Sheet M3.3 SHOP BUILDING II - FLOOR PLAN - HVAC

PROJECT TITLE
GRANT COUNTY PUBLIC WORKS OFFICE/SHOP COMPLEX
EPHRATA, WA

SHEET TITLE
SHOP BUILING II - FLOOR PLAN - HVAC

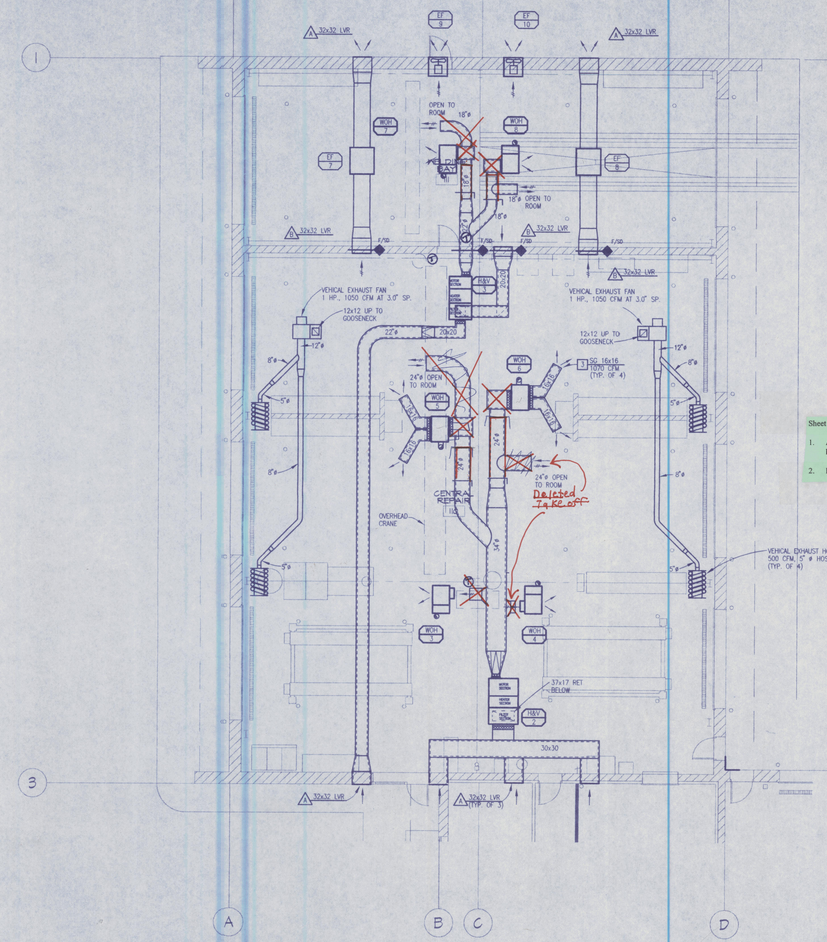
1. ADD 8" dia. type L flue through roof with flashing and termination cap at waste oil heaters WOH#3, WOH#4, WOH#5, WOH#6, WOH#7 and WOH#8.
2. DELETE makeup air outlets shown near WOH#3 and WOH#4. Add #2
